Daneros Mine Vent Shaft Reclamation Designs

*1 Working
TASK 6296
Response
NOV 4, 14*

In response to the May 28, 2014 UDOGM comments on the Daneros LM NOI, we revised/prepared the attached Vent Closure Designs. I pasted the series of UDOGM comments on this subject below:

<i>Energy Fuels Resources (USA) Inc.</i>					
REVISIONS		Project: Daneros Mine			
Date	By	County: San Juan		State: Utah	
10/22/14	RE	Location:			
		<p>Figure 4-1</p> <p>Vent Closure Design</p> <p>Cased Vent Shafts</p>			
		Author: RJE		Date: 10/24/14	
				Drafted By:

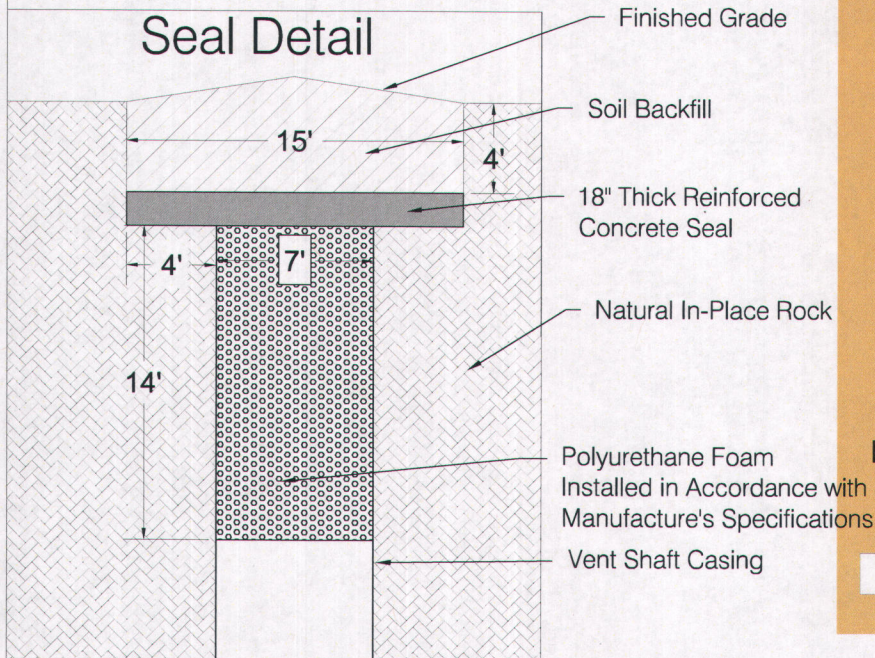
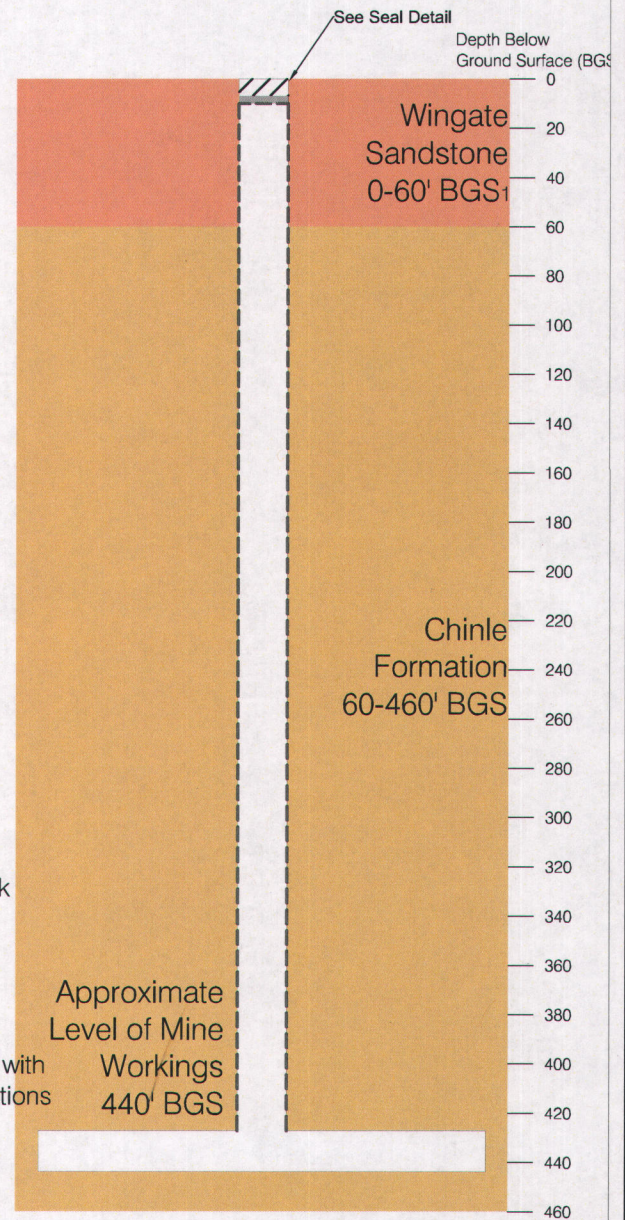
Ted, Andrea,
Sorry for the delay, I ended up having to stay home most of last week after surgery, so I just now got to them.
One comment of concern: Included in our May 28 comments was a statement that said EFR needed to count on backfilling all shafts, not just the ones that were uncased. Figure 4-1 shows a design for a non-backfilled cased shaft. Ted, are you OK with that? That is a substantial change from what our comments said.
However, with regards to these designs themselves, as long as they meet the BLM's requirements from a design standpoint, I think they are ready for the PE stamp prior to final submittal.
Thanks,

Yes Mike, I think the new shaft closure design addresses BLM's initial concerns. If I recall, the thinking for backfill was the concern that the cement cap could eventually fail due to: 1) unstable near-surface materials at some locations; 2) insufficient overlap of cap beyond the borehole (BLM guidance is to extend a distance of 1/2 diameter of borehole) and 3) question of long term integrity of casing to support the borehole wall beneath the cap. The new design calls for a 14' foam plug beneath the cap to address items 2 & 3 and increasing the diameter of the cap to 4' overlap to address item 2. Let me know if you see something we are missing and we can discuss further and if needed make additional changes.

Sounds good, Ted. As long as BLM is OK with including the non-backfilled design, I'm OK with it. Before OK'ing these, I had to go back and pull up our last comments letter to refresh myself on what was said, and it included the statement about EFR needing to count on backfilling all shafts.

So, Andrea, I think that means these designs are good and ready for finalization.

<i>Energy Fuels Resources (USA) Inc.</i>			
REVISIONS		Project: Daneros Mine	
Date	By	County: San Juan	State: Utah
10/22/14	RE	Location:	
		<div>Figure 4-3 Vent Closure Design Cased Vent Shafts With Groundwater Intercept</div>	
		Author: RJE	Date: 10/24/14
		Drafted By:

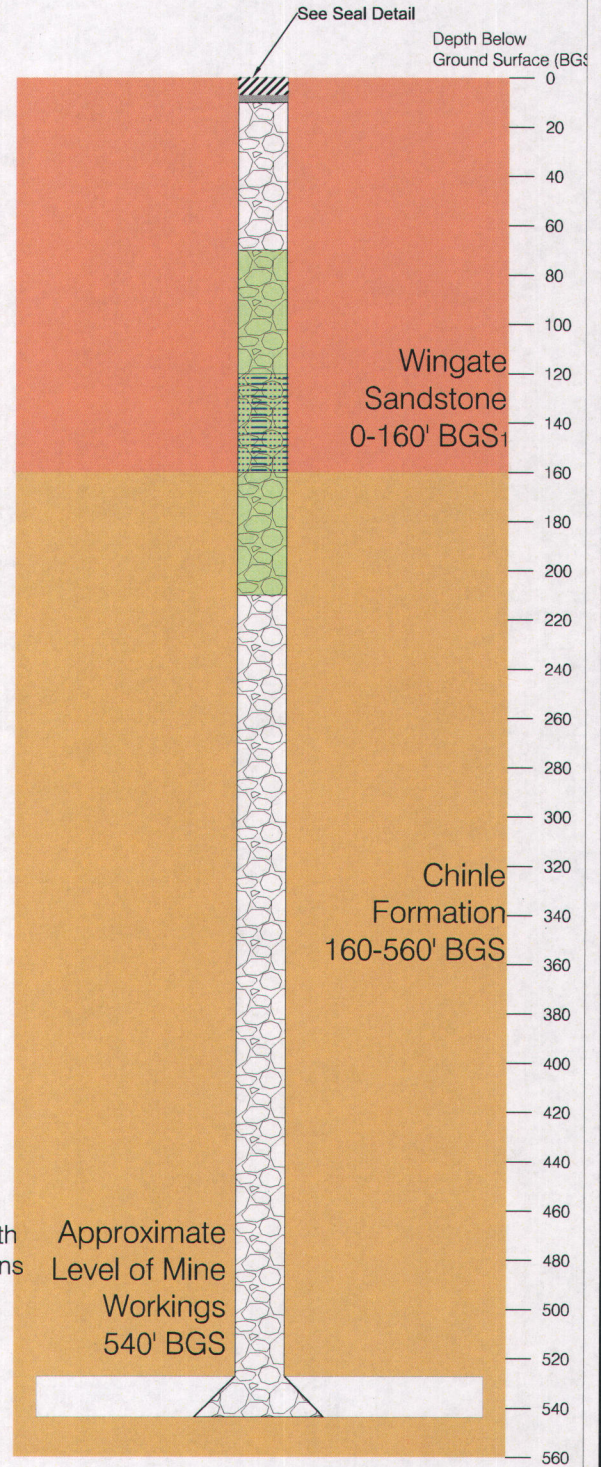
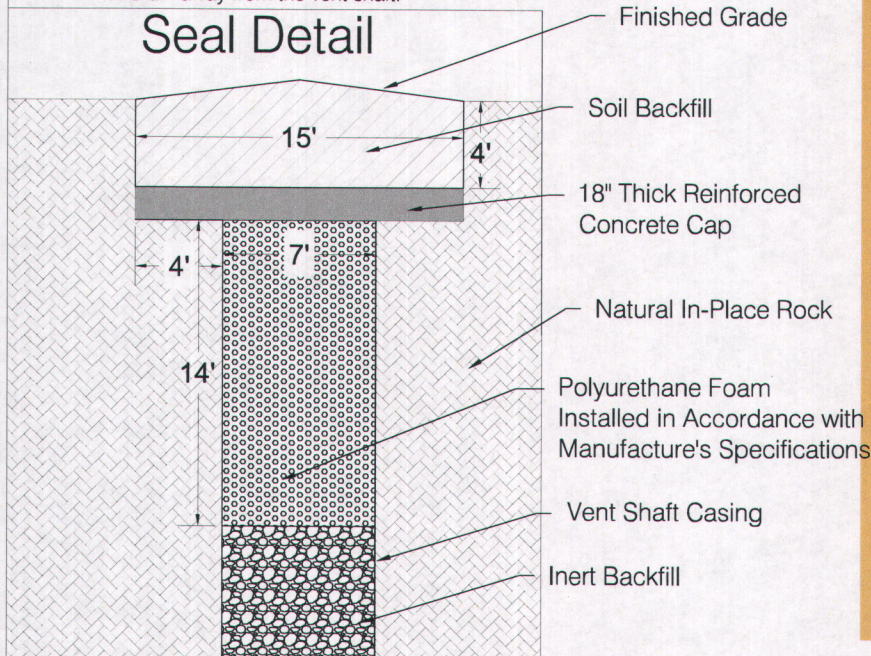
Ryan spoke with Ted recently and understood that much of the BLM's concerns about vent shaft backfill had to do with vent shafts that intercept ground water bearing formations. The attached Figure 4.3 is a new design specific to those vents. The other two existing vent closure designs, for cased and uncased vents, were also modified. All three designs now included a foam plug and a wider cement cap. Please review the attached designs and let me know if they adequately address your concerns about vent shaft reclamation. If you have **any** questions or thoughts, please give me a call. We would like to settle this issue completely so we can accurately summarize the designs in the draft EA.

The revised vent closure designs address BLM's previous concerns. Mike, once you have reviewed and are okay with the design then I think we can formalize.
